JN 23150

Subject: **Addendum to Geotechnical Report/Critical Area Study –  
Critical Area Mitigation Sequencing**  
Proposed Landscape Improvements  
8636 North Mercer Way  
Mercer Island, Washington

This addendum to our above-referenced November 20, 2024 report has been prepared to address Mitigation Sequencing under MICC 19.07.100, as required by the City of Mercer Island reviewer. We have been provided with the architectural drawings prepared by Michael L. Jones (4/10/2023) and the structural plans developed by I.L. Gross Structural Engineers (7-16-24).

Figure 6

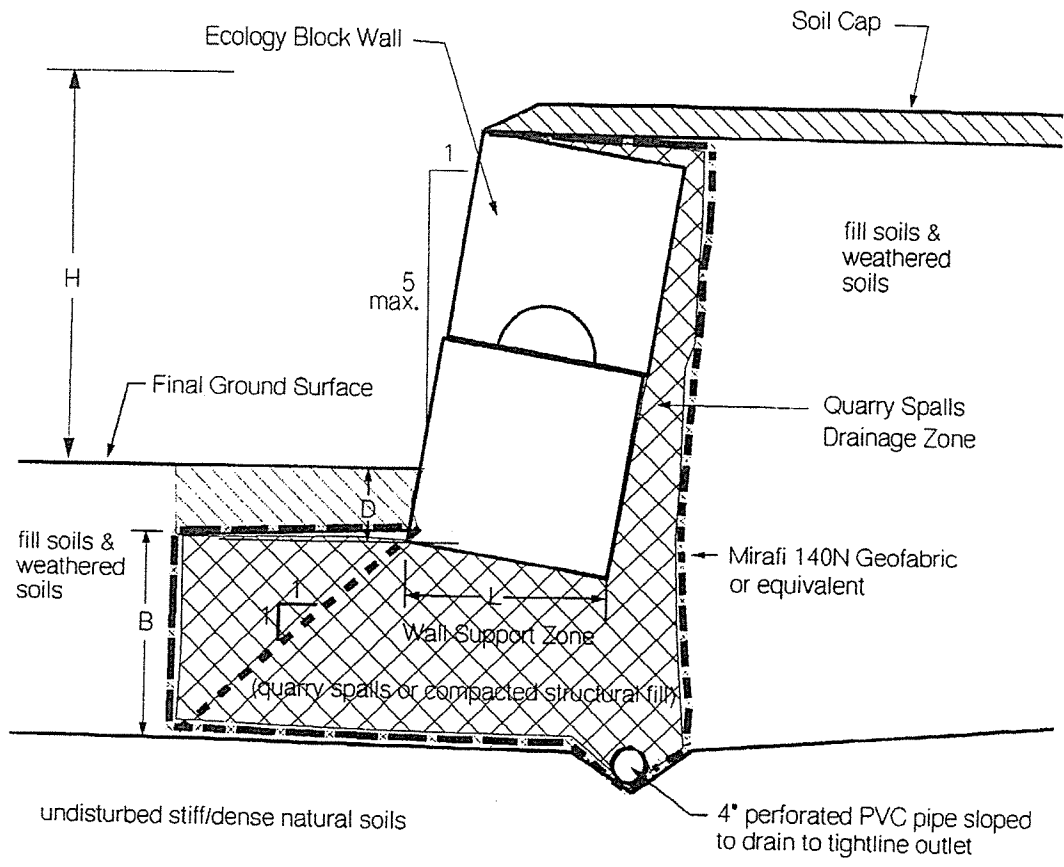
Rockery Detail: We understand that rockeries are proposed to support grade changes up to 4 feet in height in landscape areas along the lower side of the residence and on the upper side of the proposed detached garage. Based on our previous site explorations we expect the areas where rockeries are proposed may have fill and/or weathered soils exposed at the ground surface. We recommend that where fill and/or weathered soils are exposed at the proposed rockery location, the existing soils should be excavated and replaced with a zone of structural fill or quarry spalls for support of the rockery. The detail of Figure 6 attached, presents our recommendations for support and construction of the proposed rockeries.

Based on our review we find the rockery and ecology block wall facing details on the referenced C3.1 sheet to be in conformance with our supplemental recommendations for rockeries and ecology block walls as presented in this letter and the attached Figures 6 and 7.
